## REINFORCING THE CARBURETOR AIR DUCT AND OTHER MUSTANG MODIFICATIONS FROM THE 24 JULY 1943 ISSUE OF NAA WEEKLY SERVICE NEWS

FIGURE 1: Illustration of how the strengthening modification would be undertaken.

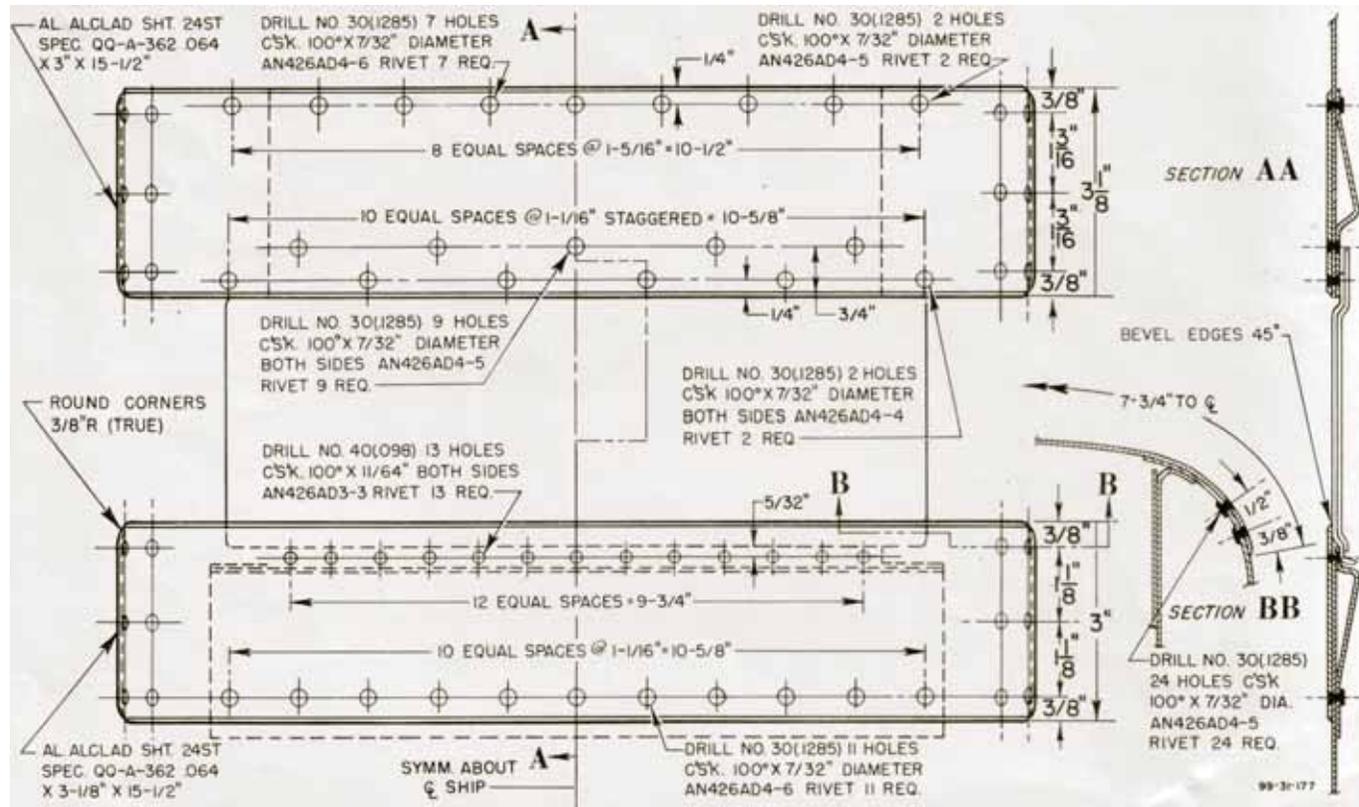
Layout of the two 24ST Alclad (.64) reinforcement strips is shown in FIGURE 1.

When the strips are cut and drilled they will serve as templates when drilling the holes in the cowling skin. A few holes will have to be countersunk on the underside of the skin.

"C" clamps are used to hold the strips tightly against the skin, binding them to fit the contour of the cowling.

FIGURE 2: The reinforcement strips would prevent the panel from possibly blowing off as a result of a backfire.

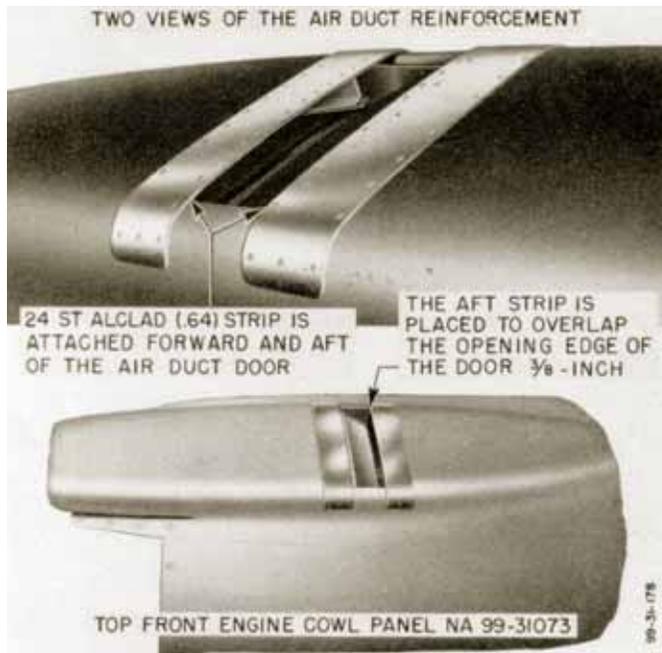
A corrective measure has been undertaken by Engineering to prevent engine backfires from damaging the air filter door on the P-51A series. This is accomplished by two 24ST Alclad (.64) strips forward and aft of the air duct door as shown in FIGURE 2. These reinforcement strips have been tested under normal conditions at the factory and proved satisfactory.

The forward strip is placed along the edge of the hinge in the air

duct door. The aft strip is placed to overlap the opening edge of the door 3/8th-inch (FIGURE 2).

The strips are centered in line with the center of the air duct door

and when in this correct position they are first riveted at the two outboard center holes on the edge. This will hold them so that the balance of the riveting may be done properly.

FIGURE 4: The bellcrank rework.

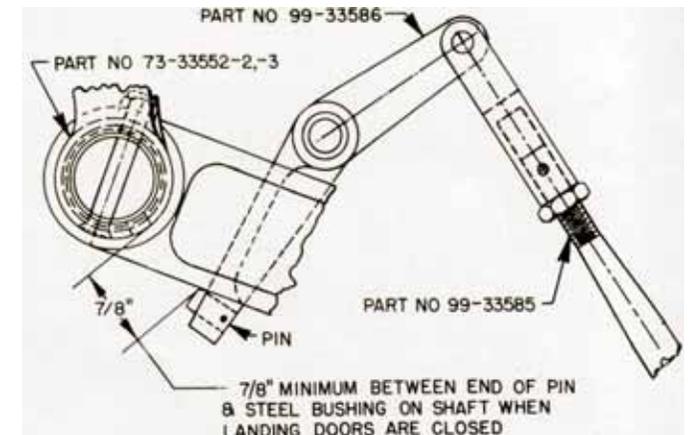
To prevent bending and shearing of the pin in the bellcrank (NA 99-33586) on P-51A, P-51B, and P-51C pursuits, as has been reported from the field, Engineering recommends the following action be taken.

Inspection and necessary adjustments should be made to provide a 7/8th-in minimum clearance between the end of the pin and the steel bushing on the shaft when the landing gear doors are closed (FIGURE 4).

The doors are deflected by the air loads during flight, thereby allowing bellcrank (NA 99-33586) to lock the landing gear controls when pin engages hole in tube assemblies (NA 73-33552-2-3). This condition can be prevented by maintaining a distance of 7/8th-in minimum between tube and pin when doors are closed.
